Re: Water Use License 1BR-DYE0409

UMA Engineering Ltd. is submitting the following proposed modifications as per Section H.1 of the existing license. The notification of modifications is being submitted on behalf of Defence Construction Canada and the Department of National Defence.

The following modifications are being proposed as part of the clean up of the DYE-M, Cape Dyer DEW Line site.

DRAWING TITLE:
**NEW SEWAGE
LAGOON-2008**

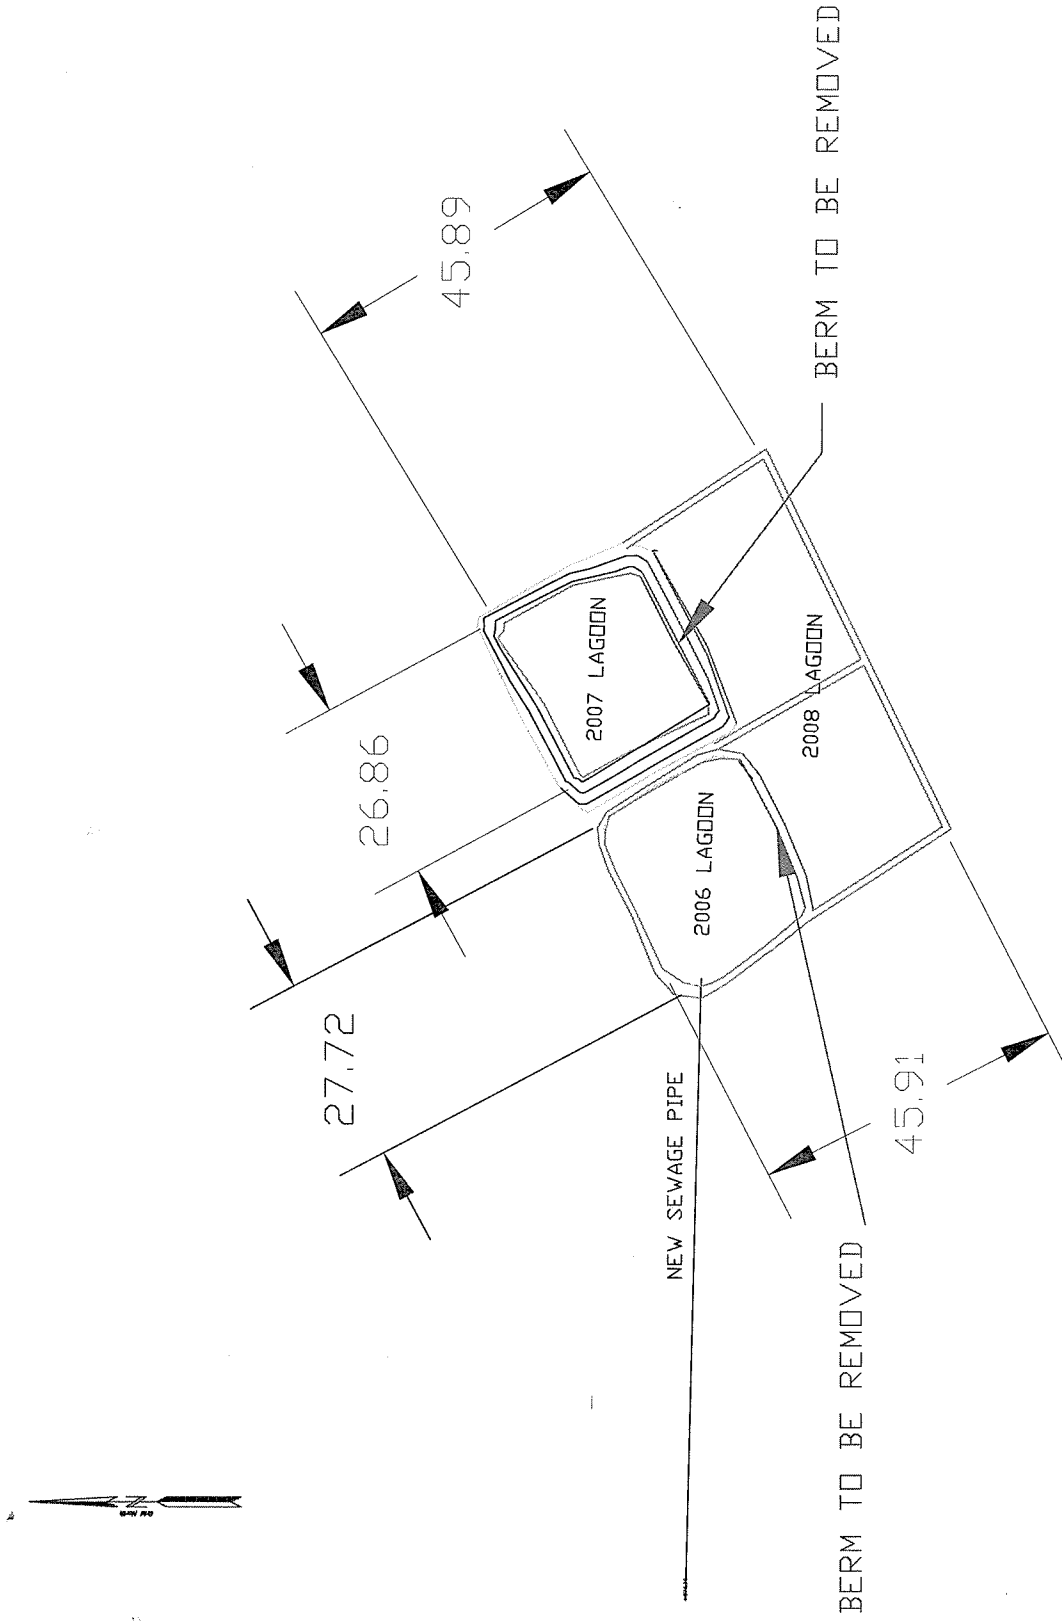
- 1.) The camp will increase in size to a maximum of 165 people. Although the number of people at the camp will significantly increase, based on the water usage to date, the currently licensed quantity of water at DYE-M will be sufficient and there is no need at this time to apply for an increase in water usage. In addition, the two cells of the camp sewage lagoon are being expanded to support the increase in camp size. A figure indicating the limits of the expansion was provided by the contractor and is attached for reference.

SUBJECT – SUJET
HEATED VEHICLE STORAGE
PLAN, SECTION AND ELEVATIONS

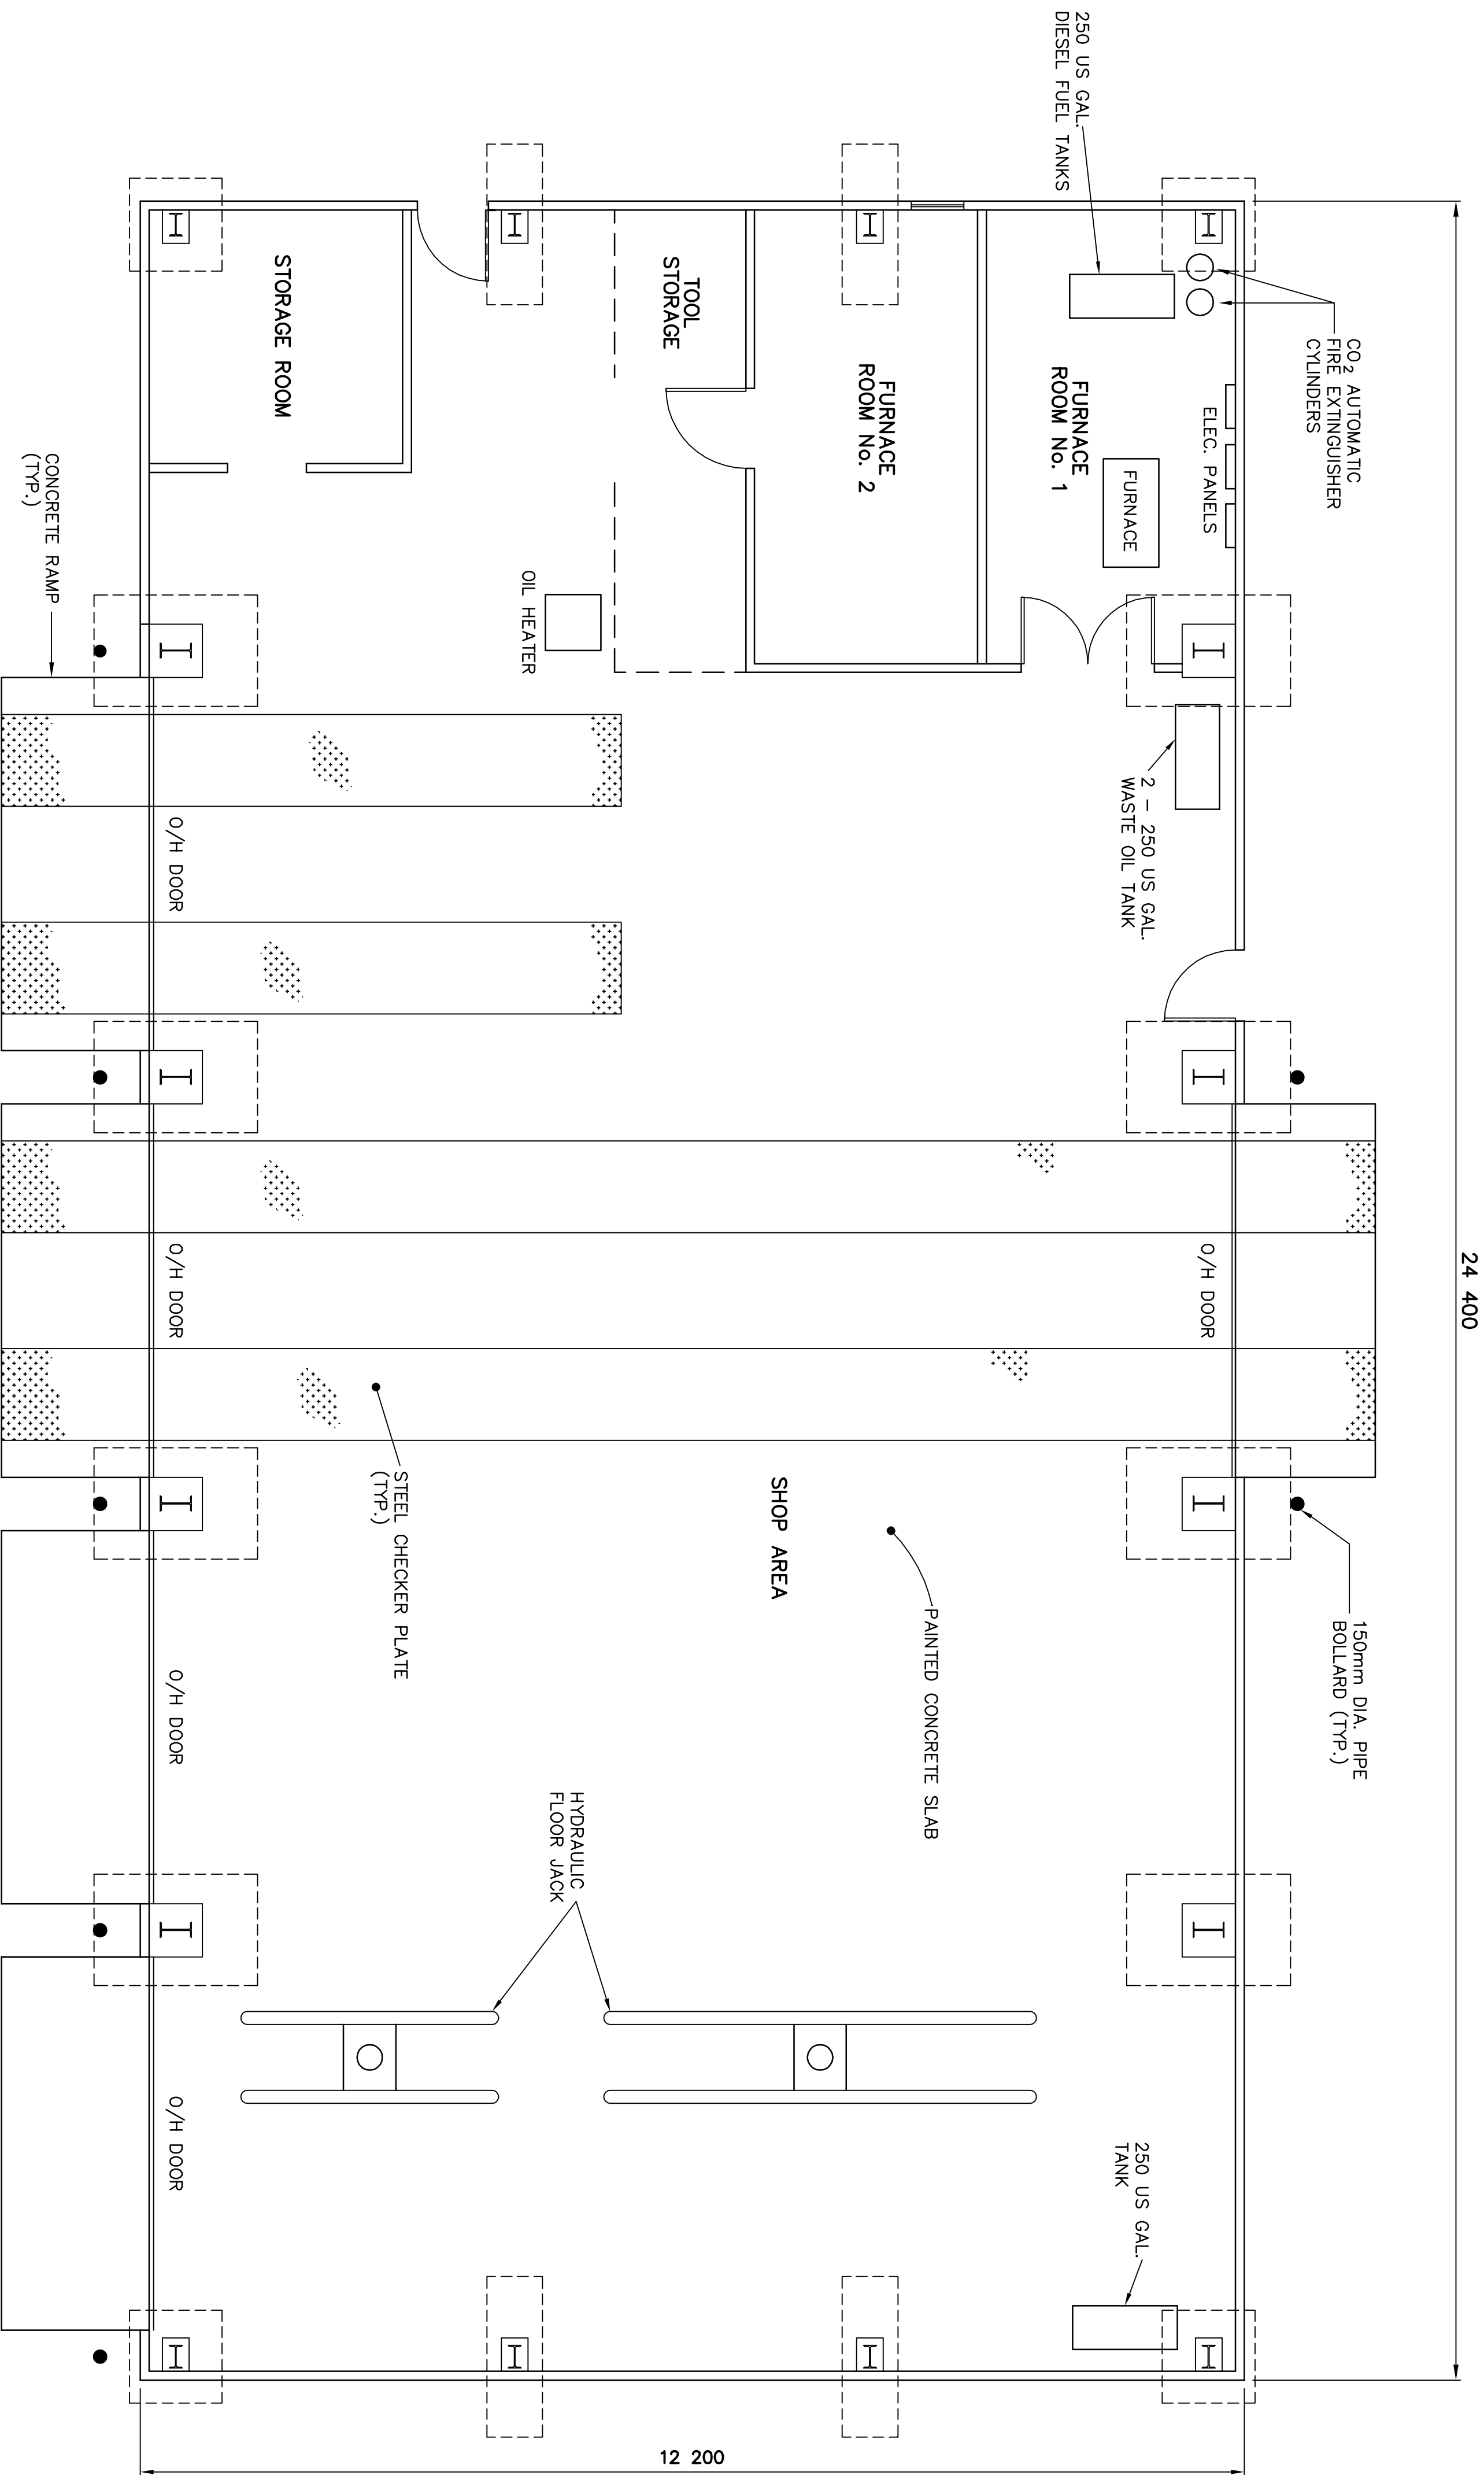
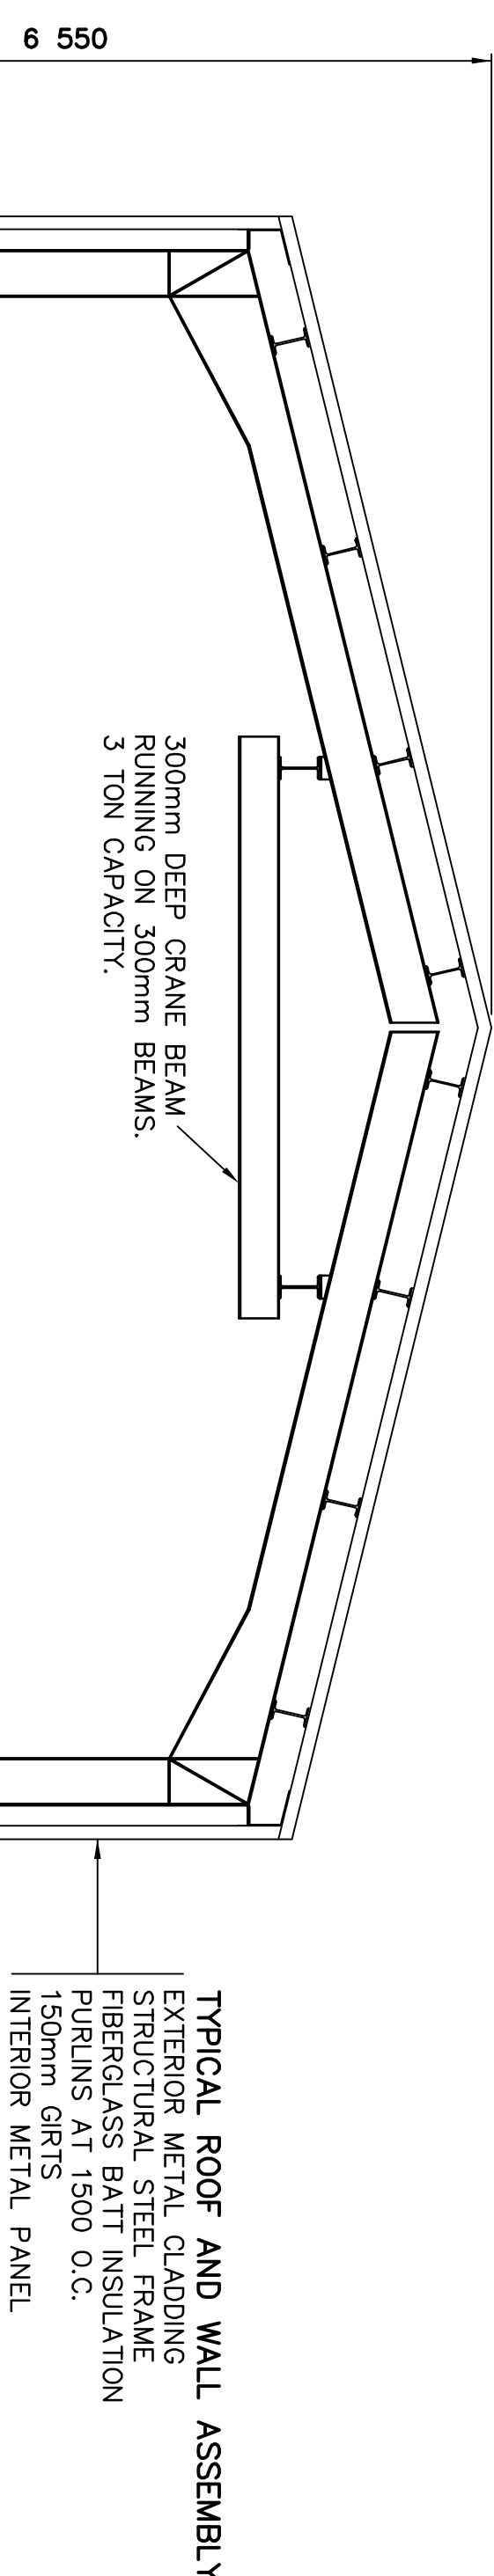
- 2.) Nine additional buildings at the Lower Site are to be demolished, including the air terminal building, four warehouses, two atwell dormitories, the heated vehicle storage building and the garage. However, the demolition of module train C and the walkway from module train B to module train C identified for demolition in the original submission will be cancelled and the buildings will remain.

The demolition work will include excavation and disposal/treatment of contaminated soils below and near the additional facilities to be excavated and the on-site transport, handling, classification, consolidation and containerization of approximately 400 full or partially full barrels of liquid waste stored within the heated vehicle storage building.
